SUBJECT: CORE RELOAD FOR CYCLE 2 (TAC NO. 66775)

Re: HOPE CREEK GENERATING STATION

AMENDMENT TO FACILITY OPERATING LICENSE

Amendment No. 15
License No. NPF-57

Figure 3.2.1-1

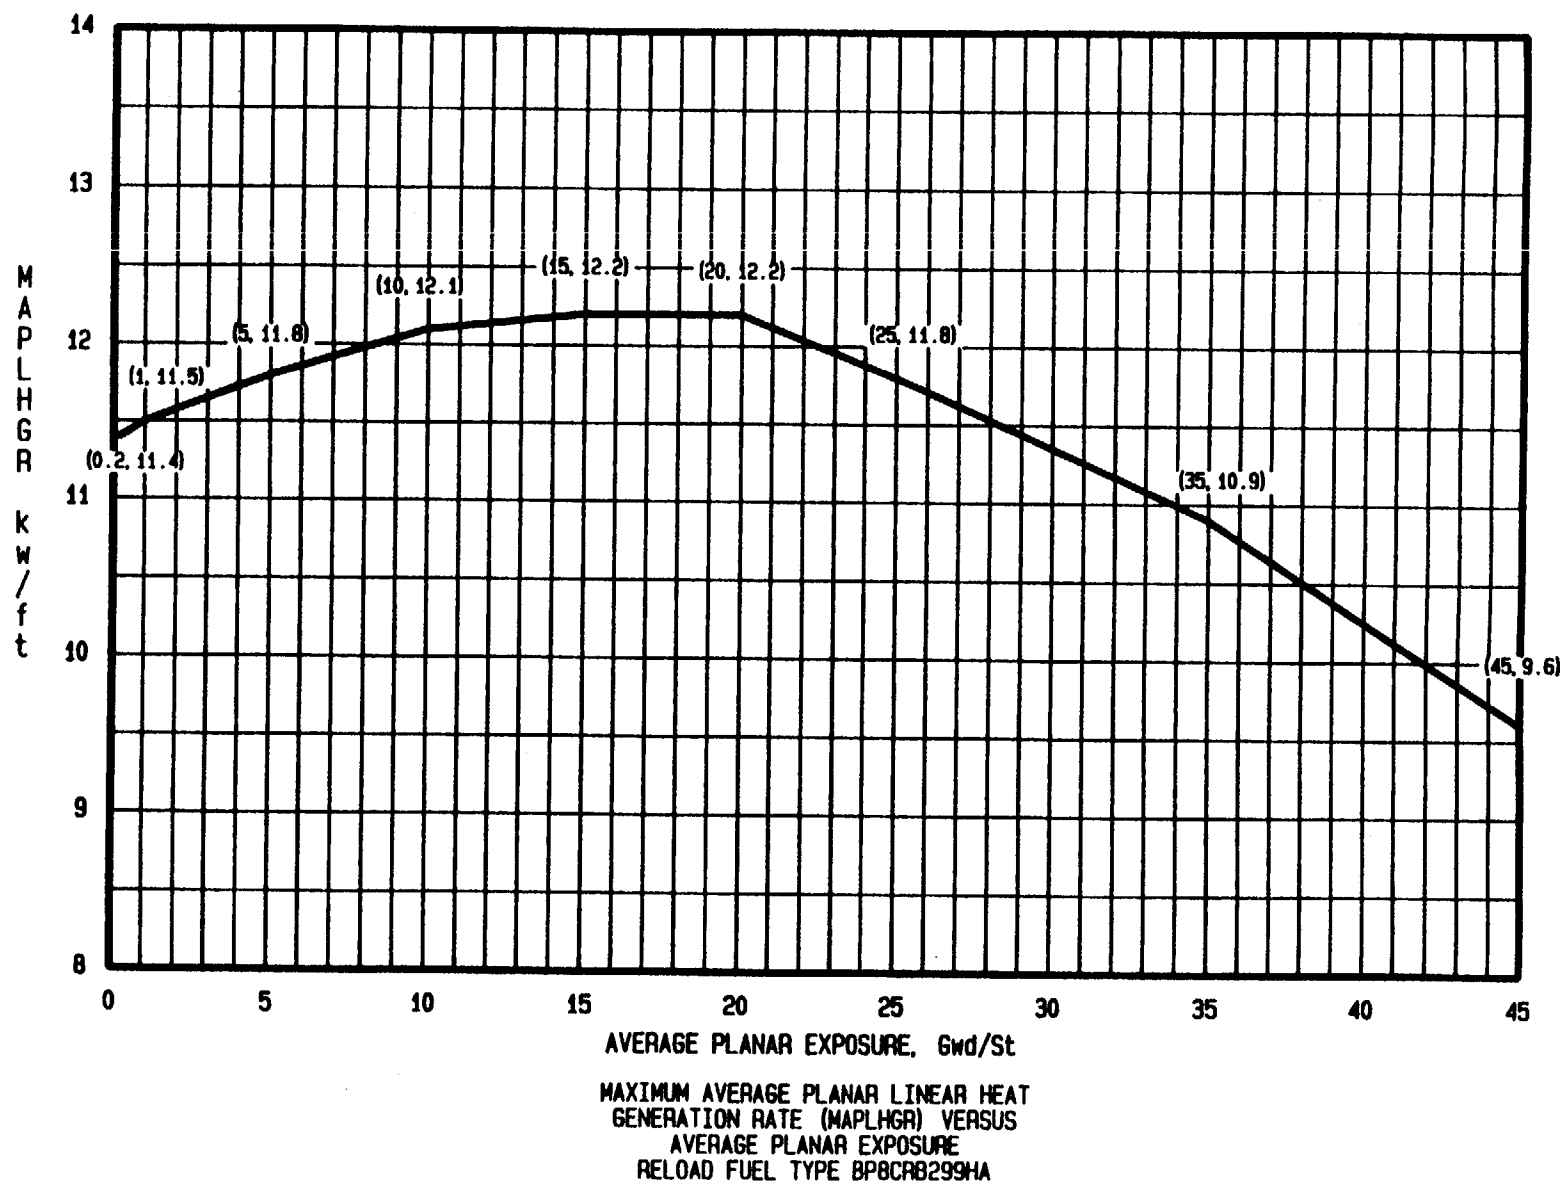
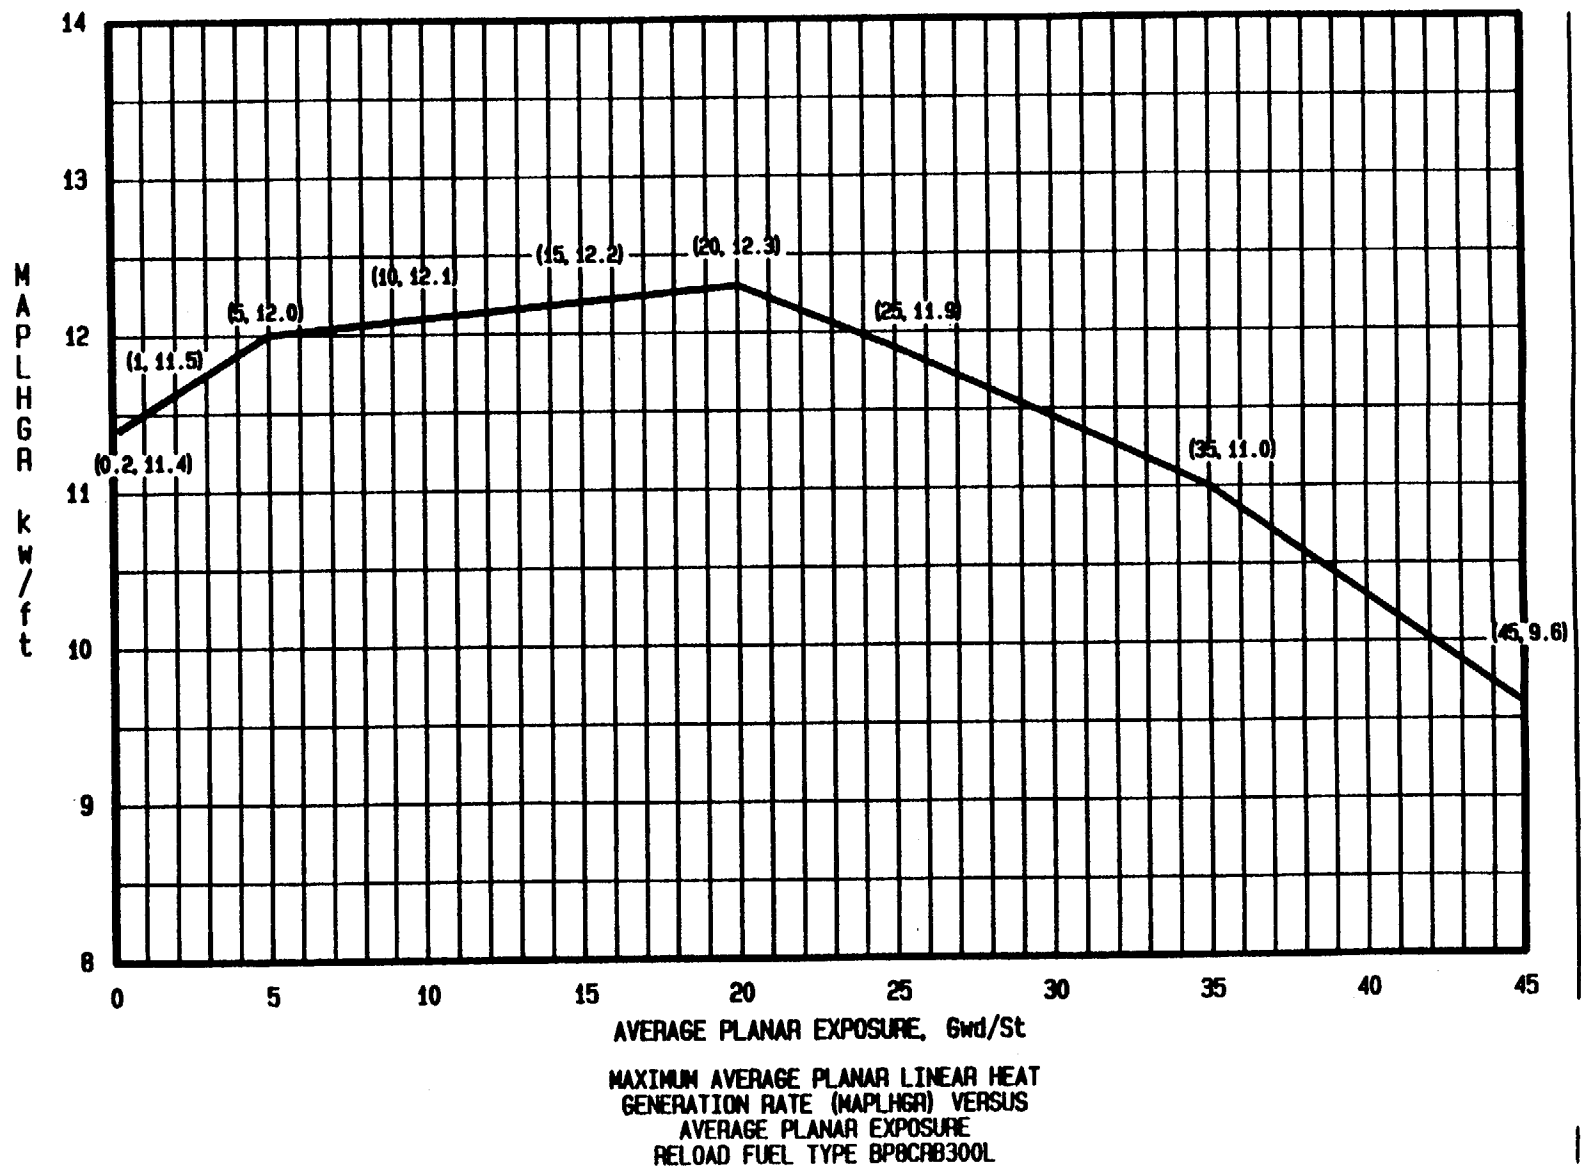
Figures 3.2.1-1 and 3.2.1-2: These figures have been changed to contain the Maximum Average Planar Heat Generation Rate (MAPLHGR) curves for the two new fuel types instead of the two types that were discharged. The new MAPLHGR curves are consistent with the results of the LOCA analyses and are acceptable.

Figure 3.2.3-1

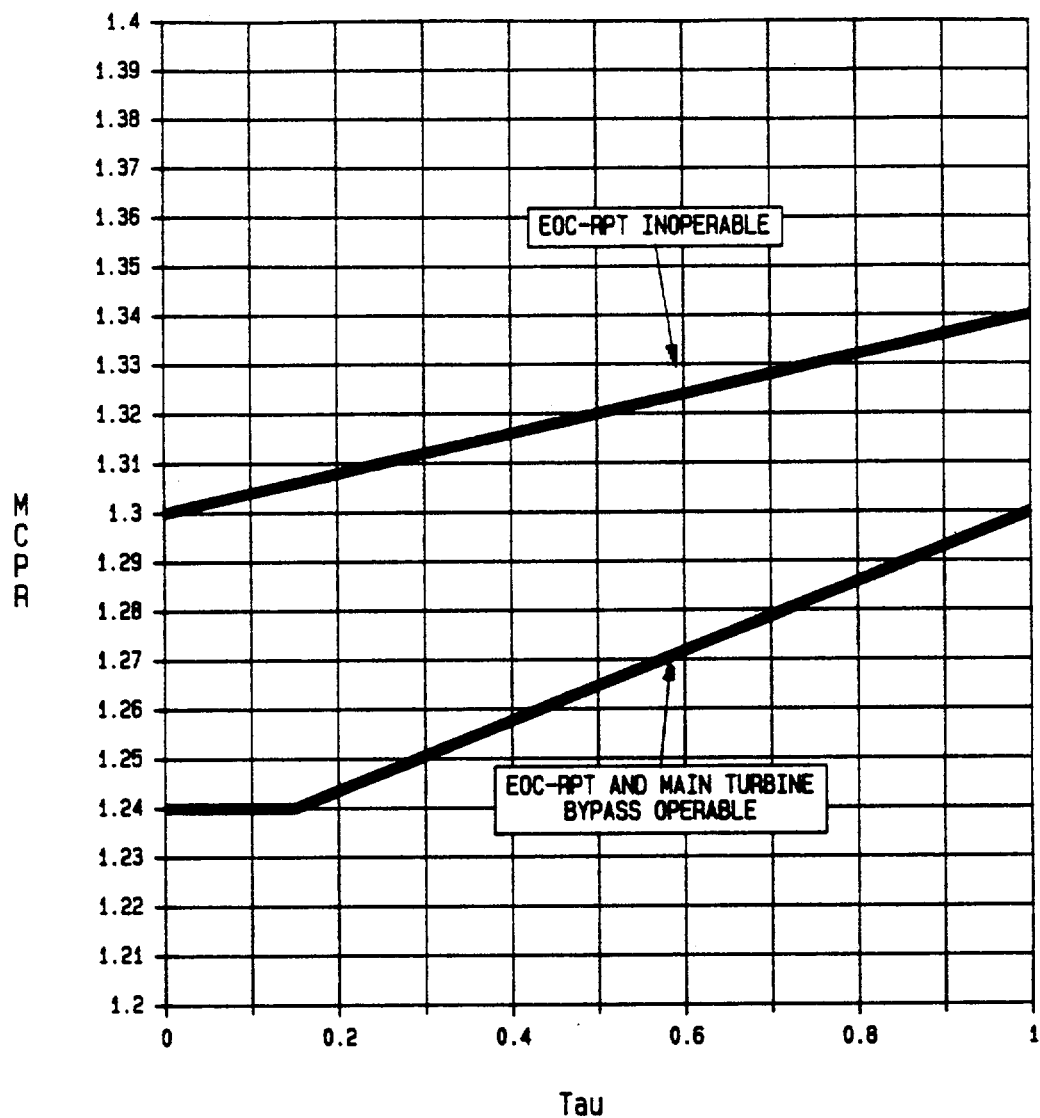
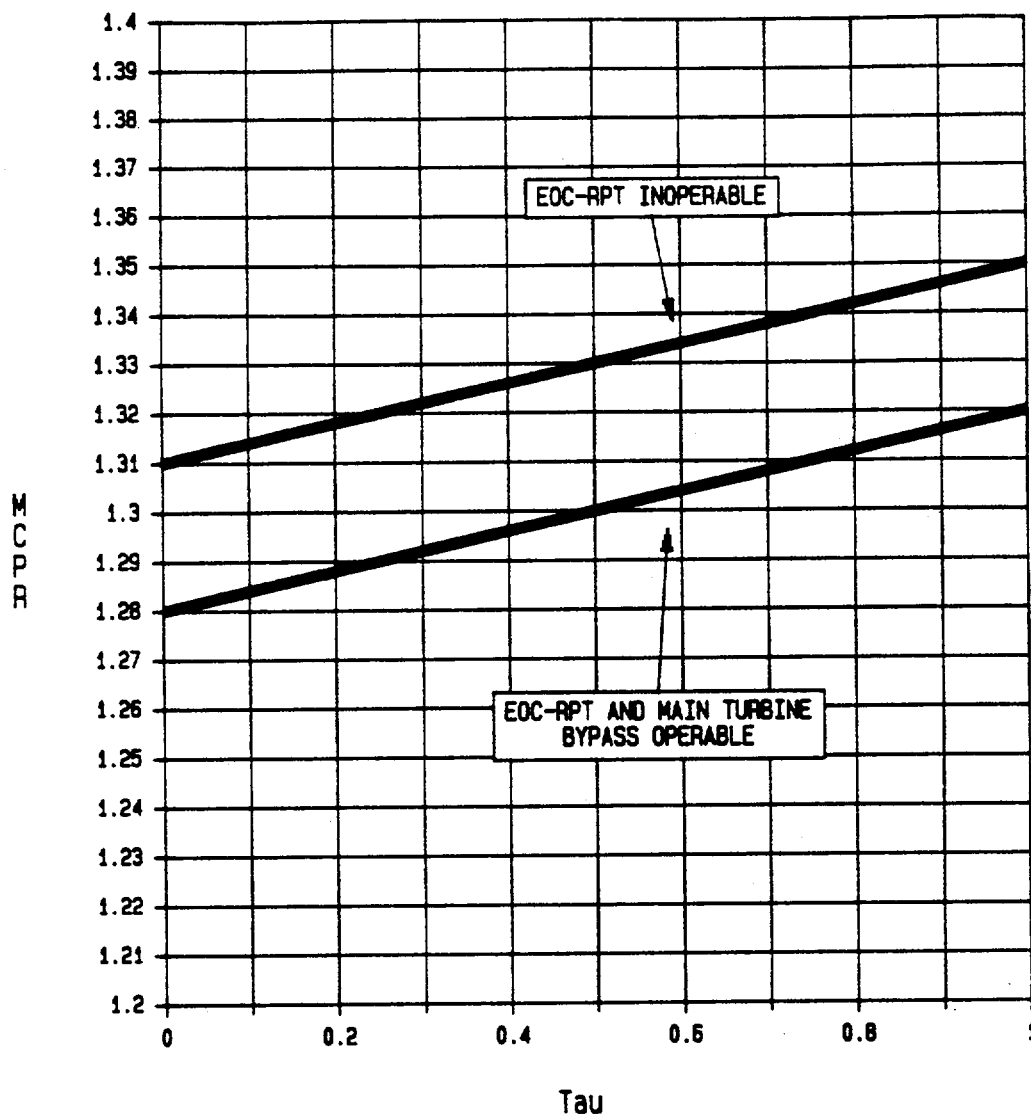
Specification 3/4.2.3 Minimum Critical Power Ratio (MCPR): A number of changes have been made to this specification. The single figure (3.2.3-1) of operating MCPR as a function of normalized scram time has been replaced by two such figures. This change was necessitated by the choice of the exposure dependent limits option. Two exposure bands were chosen-hence two figures. This is a widely used option and is acceptable for HCGS. The original figure 3.2.3-2 has been renumbered 3.2.3-3.
